**City of Oakland
Objective Design Standards and
Project Streamlining**

**Focus Group Meeting #2
August 30, 2023**

Subject: Objective Design Standards (ODS) Focus Group #2– Oakland Heritage Alliance (OHA) comments

Curb Cut Frequency: For developments other than one to four units and townhouses:

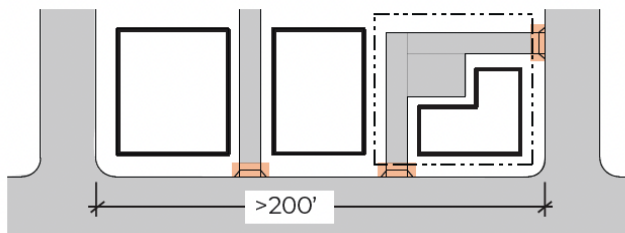
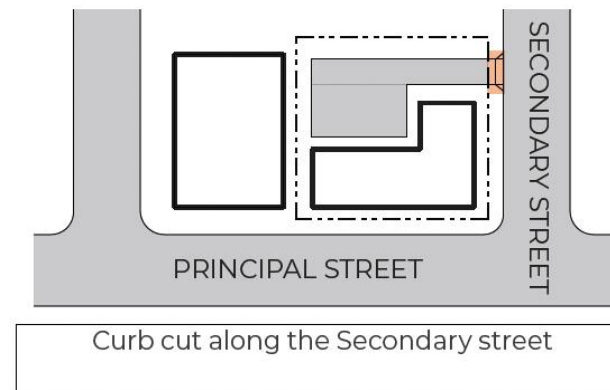
- “only one curb cut should be *allowed*...” in first bullet- implies one must be provided.

This might be nitpicky, but since the goal is a clear standard, should the standard read "Only one curb cut shall be ALLOWED" for the first bullet point? If a project chooses to not provide a curb cut, that would be ok right? As it's written, it sort of implies one must be provided.

Landscaping

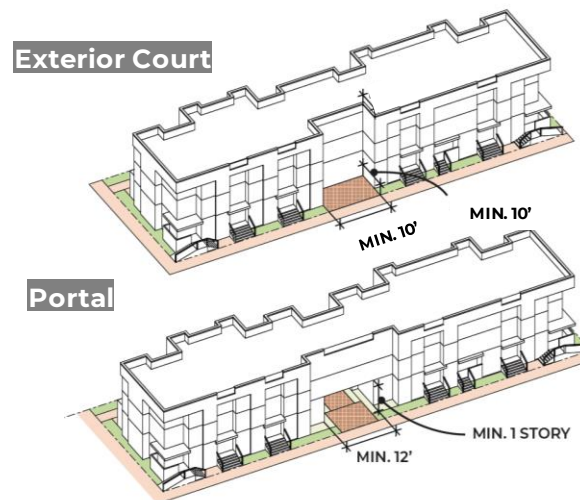
- Roof terraces and above-grade landscaped areas should have the flexibility to reduce planting at these areas to 15-20%. Trellises are another effective landscaping option.

Agree that roof terraces and above grade landscaped areas should have the flexibility to reduce planting at these areas to 20%? 15%? Trellises, etc are effective

Massing Breaks. For building frontages and continuous streetwalls up to eight stories tall and greater than or equal to 150 feet but less than 300 feet in lengths, massing breaks shall be provided as at least one of the following:

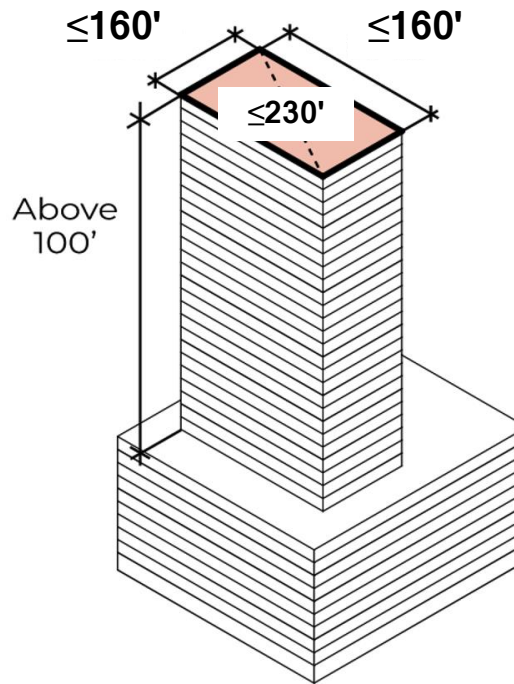
- Specifically can we scrap the recess or projection massing, exterior court, & portal requirements?
- Agree that horizontal articulation is important, but 10' depth is unnecessarily deep to convey a visual sense of "break"- 3' is more reasonable. For housing, this would allow more flexibility.
- Don't think this would contribute to better buildings
- 150' to 300' spacing requirement seems reasonable

- Massing breaks- don't think they are necessary, make buildings architecturally bland.- scrap the recess or projection massing, exterior court, & portal requirements (+4)
- Helpful to identify entry that has recess, but can busy and random. Other standard for articulation needed. Upper 2 levels set back, 8-10 ft, helps articulate building (vertical articulation)

- In historic areas (primary and secondary importance), OHA recommends new development respect contextual arch. Elements. Most historic areas don't have that much articulation, but do have detailing, façade rhythm, etc. Recommend new development pick up on contextual elements. Can be visually intrusive otherwise.
- Articulation can increase costs; other design features may be more cost effective

Primary Building Entrance for Lobbies: A primary building entrance that leads to a residential or commercial lobby shall provide:

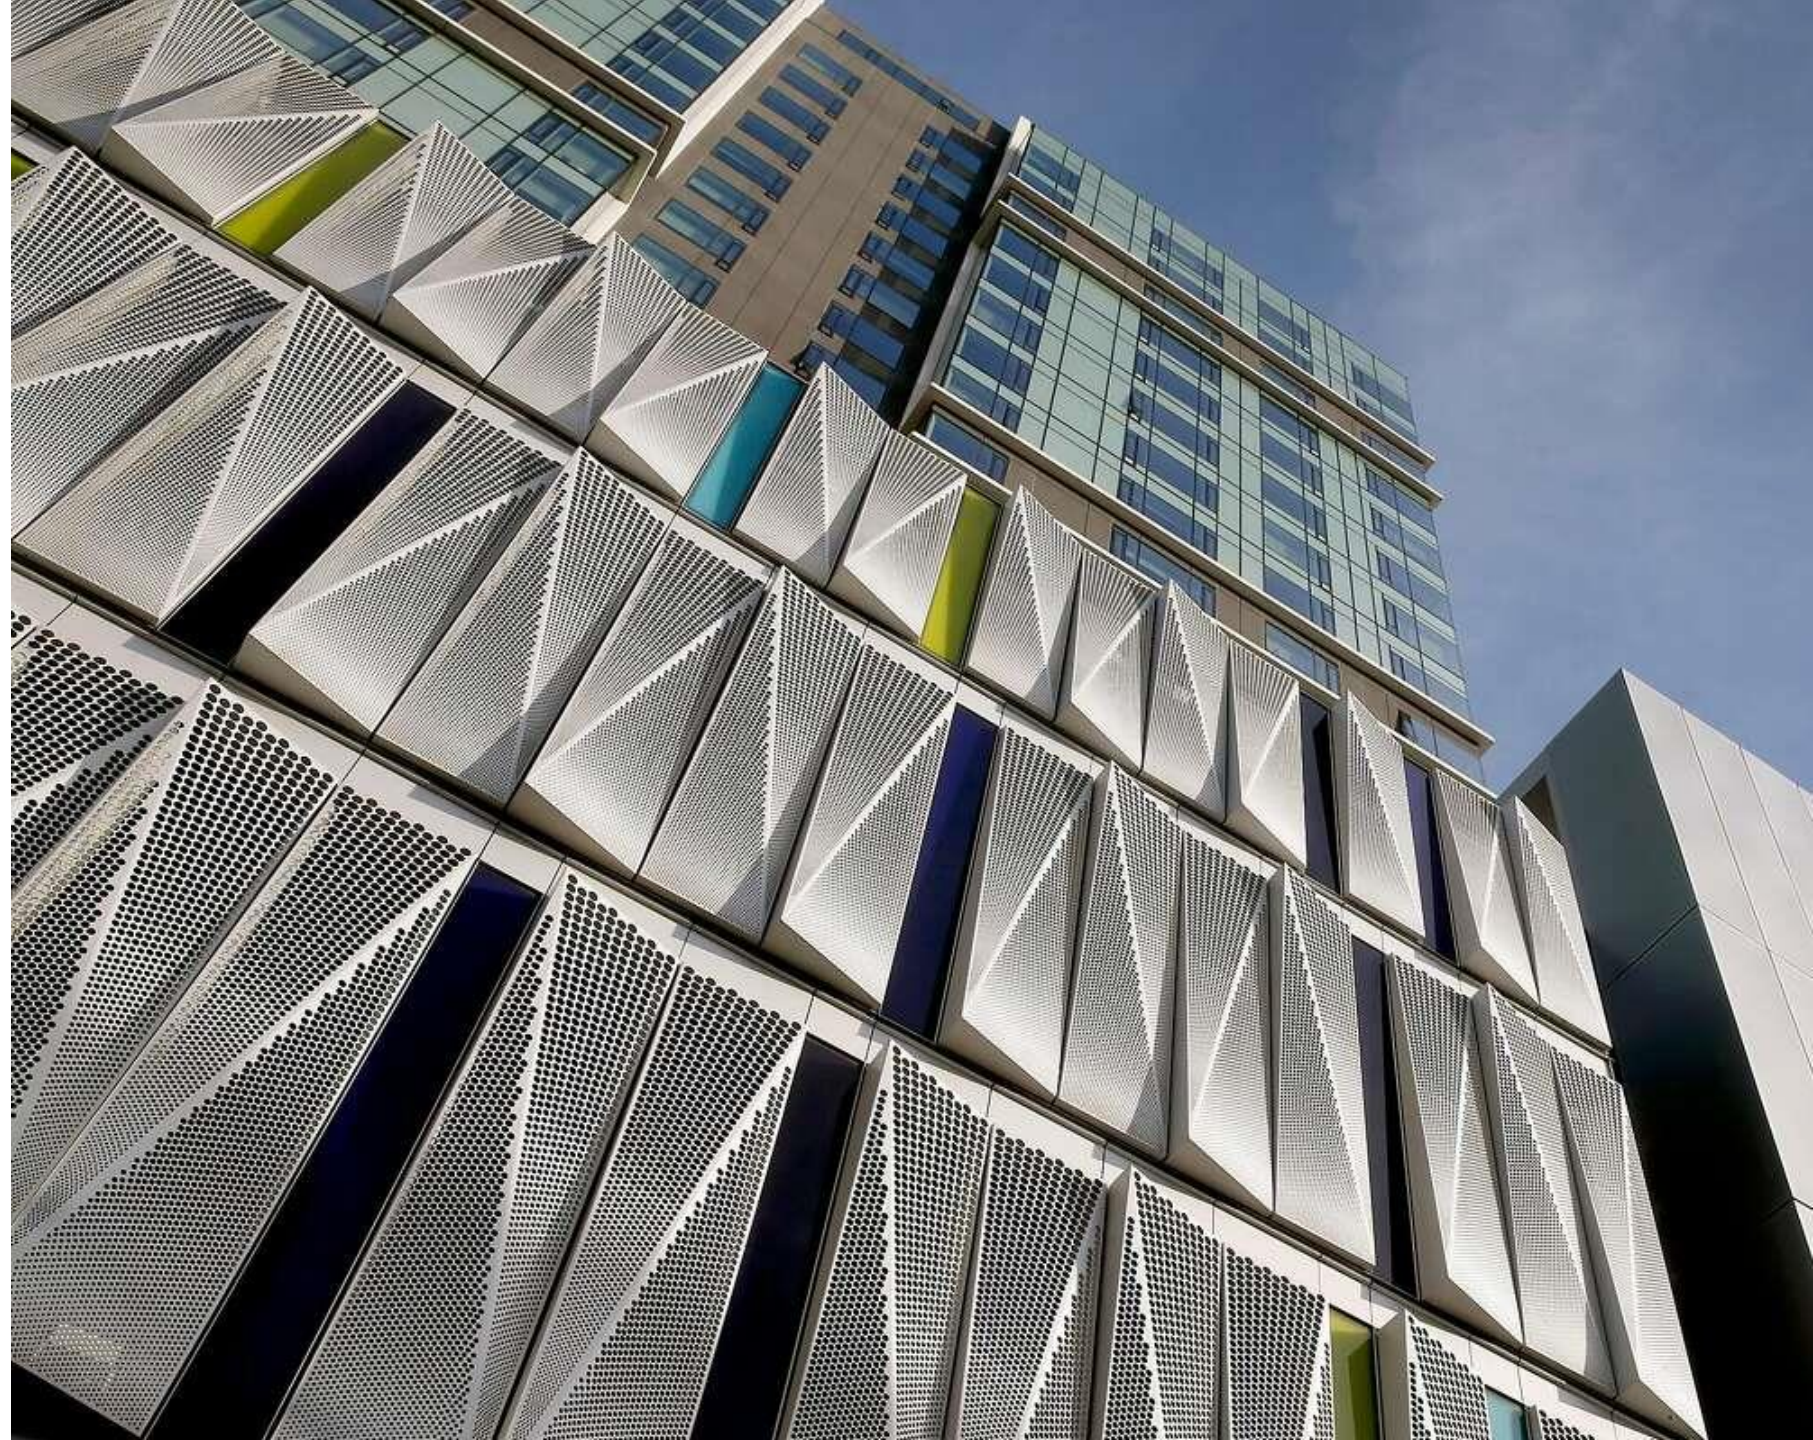
- Minimum 10' - make more flexible for 'missing middle'/smaller developments

Agree that 10' could go to 9'

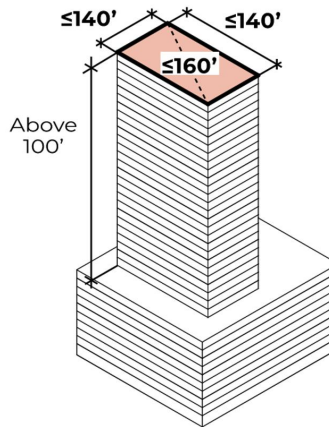
DELETE. Too many articulations. Design is too cluttered and visually disruptive and would be highly intrusive in APIs, ASIs, and most existing Oakland neighborhoods and commercial districts. Designs like this should be subject to discretionary design review.

Tower Floorplate: For portions of the building over 100 feet in height, the dimension of the longest building side and the diagonal shall not exceed 140 feet and the longest diagonal shall not exceed 160 feet.

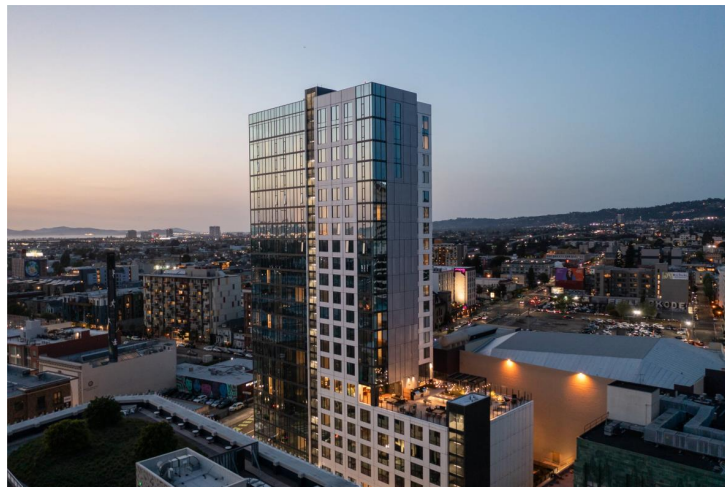
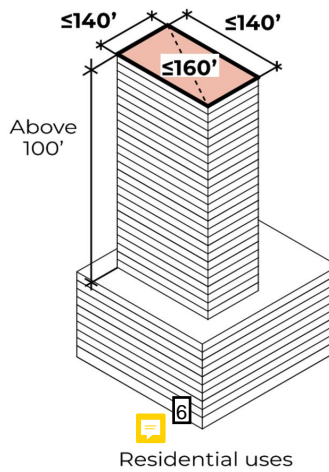
These provisions improve the existing tower provisions in the zoning regulations, but should stay in the zoning regulations, since that is where the other height setback, and other building envelope standards reside. The proposed provisions also need further work, including minimum separation between towers. See 7/6/23 OHA Focus Group #2 letter.

Provide tower setback standards to minimize wind acceleration impacts at street level.

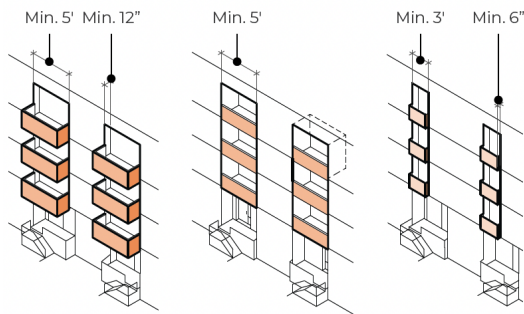
Provide better example. The vertical plane changes are more pronounced than the material/color changes.

Parking Garage Facades: For parking garages with a longer than 30 feet of exposed façade, a minimum of 75 percent of the public space-facing parking garage façade and a minimum of 50 percent of the local streets-facing parking garage façade shall be articulated at least one of the following:

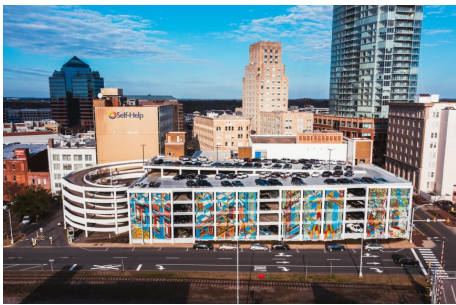
Provide techniques intended to make parking garages look less like parking garages, e.g. avoid strong horizontal articulation, provide vertical divisions no more than 5' wide to resemble window openings, and provide architectural elements such as pilasters and/or moldings. See parking garage photos attached to OHA 9/6/23 focus group #2 letter.

Mid-rise Residential Building in Oakland

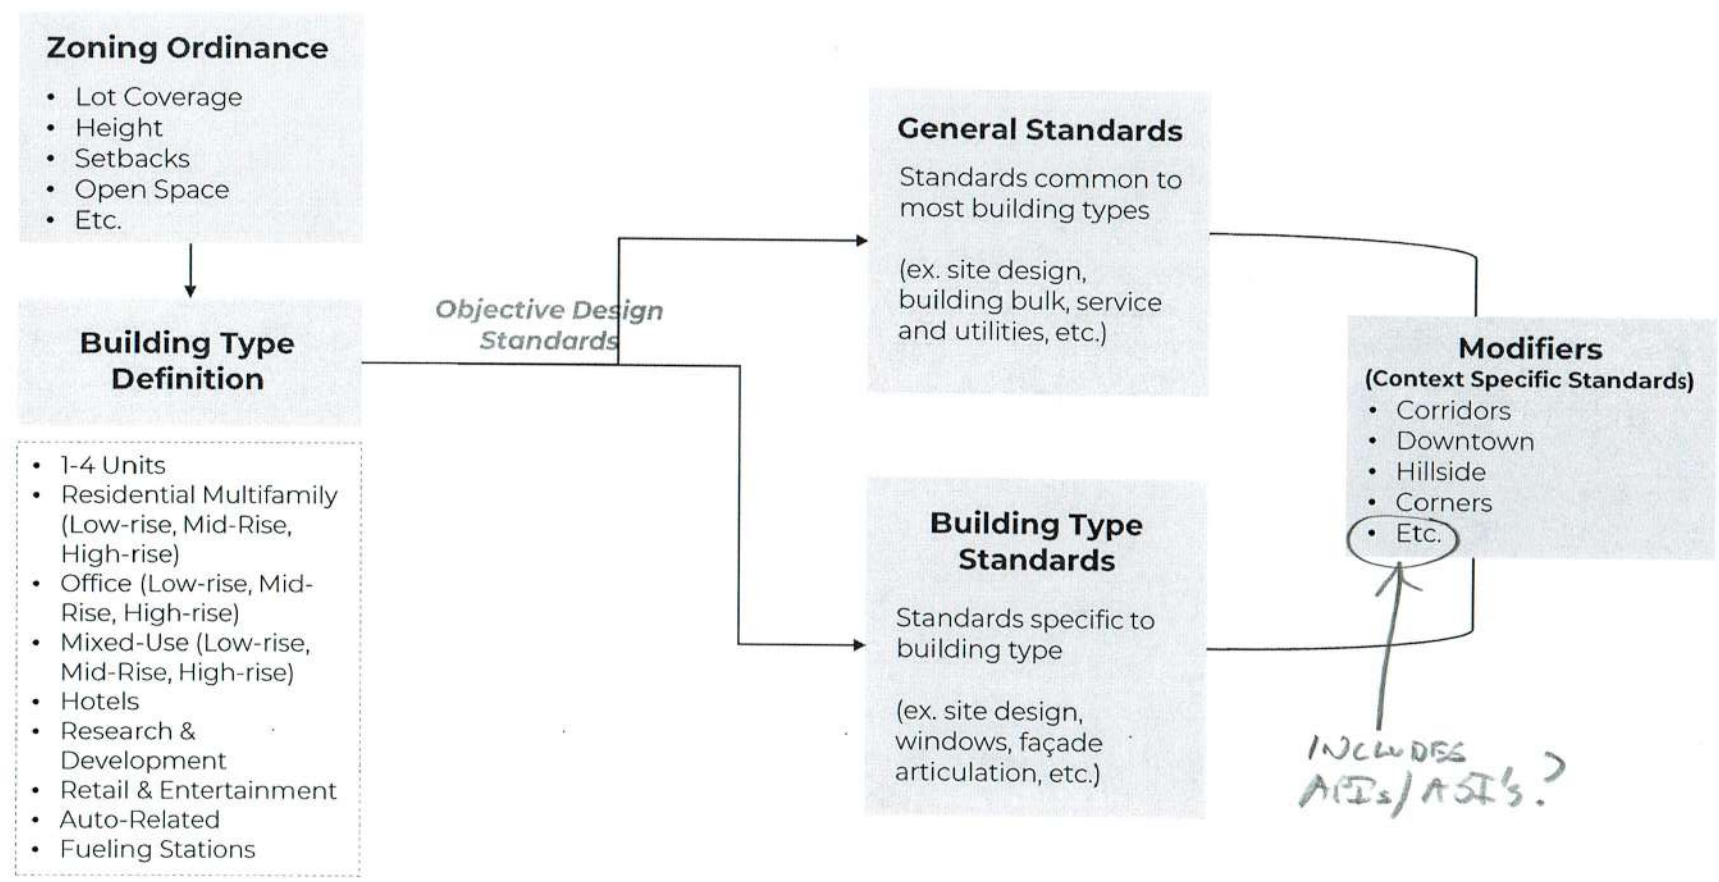
OVERLY ASSERTIVE DESIGN WITH CANTILEVERS,
 OVERSCALED FLOOR PLATES ON TOP THREE FLOORS,
 (RESULTING IN TOP-HEAVY APPEARANCE AND IRREGULAR
 ARRANGEMENT OF PUNCH-OUT WINDOWS.

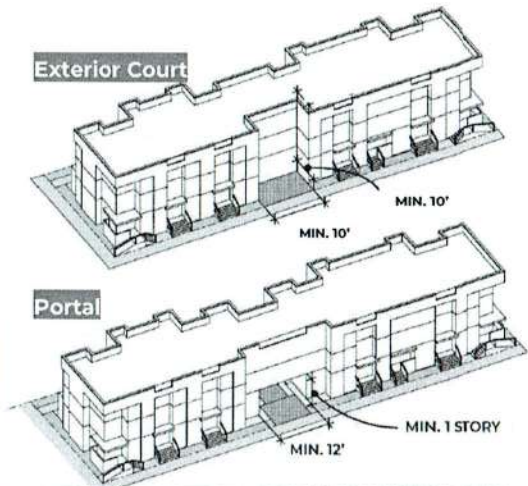
GOOD DESIGN CONSISTENT WITH MANY HIGH INTENSITY APIS/ASIS, BUT PRIMARILY DUE TO REGULAR + MOSTLY SYMMETRICAL FACADE COMPOSITION AND RHYTHM, ARTICULATION OF LOWER LEVELS WITH CHANGE OF MATERIALS AND TOP LEVEL WITH BILT COURSE AT BASE + TRUSSSES, + USE OF MODERN/ART DECO ARCHITECTURAL STYLE. FACADES ARTICULATIONS ARE WELL-HANDLED, BUT NOT ESSENTIAL TO API/ASI COMPATIBILITY NOR TO THE SUCCESSFUL DESIGN.

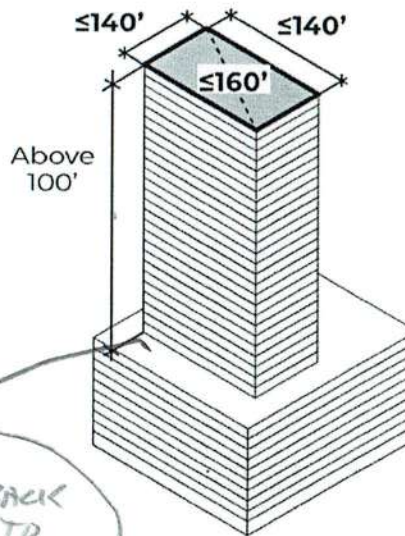
DELETE - TOO MANY ARTICULATIONS. DESIGN IS TOO CLUTTERED + VISUALLY DISRUPTIVE. WOULD BE HIGHLY INTRUSIVE IN APIS/ASIS AND MOST EXISTING OAKLAND NEIGHBORHOODS + COMMERCIAL DISTRICTS. DESIGNS LIKE THIS SHOULD BE SUBJECT TO DISCRETIONARY DESIGN REVIEW.

Residential uses

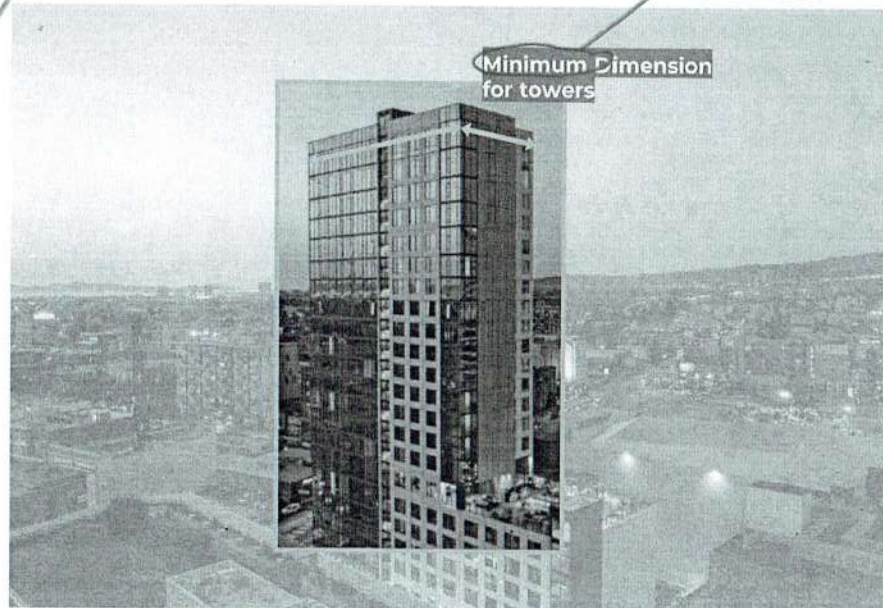
IS THIS A MISTAKE?
130
MAXIMUM!

PROVIDE TOWER SETBACK STANDARDS TO MINIMIZE WIND ACCELERATION IMPACTS AT STREET LEVEL.

Vinyl

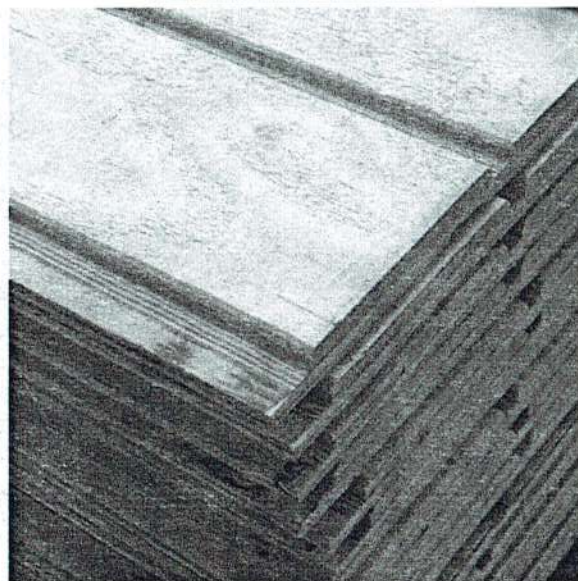
PROHIBIT VINYL SIDING EVERYWHERE, NOT JUST DOWNTOWN GIVEN ITS ENVIRONMENTAL ISSUES, INSUFFICIENT LONGEVITY & SYNTHETIC APPEARANCE.

Material and Color Changes

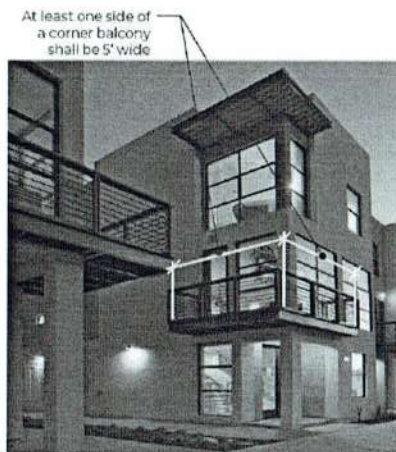
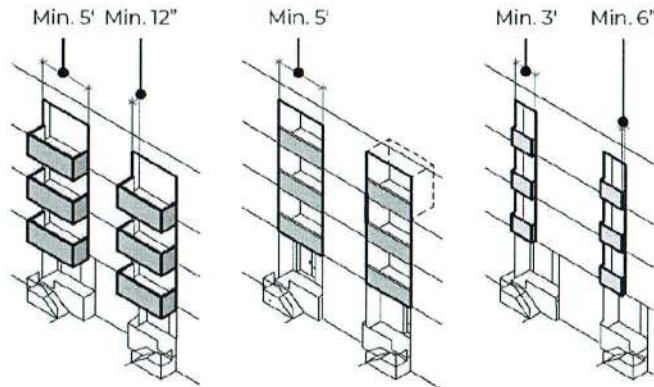
PROVIDE BETTER EXAMPLES. THE VERTICAL PLANE CHANGES ARE MORE PRONOUNCED THAN THE MATERIAL/COLOR CHANGES
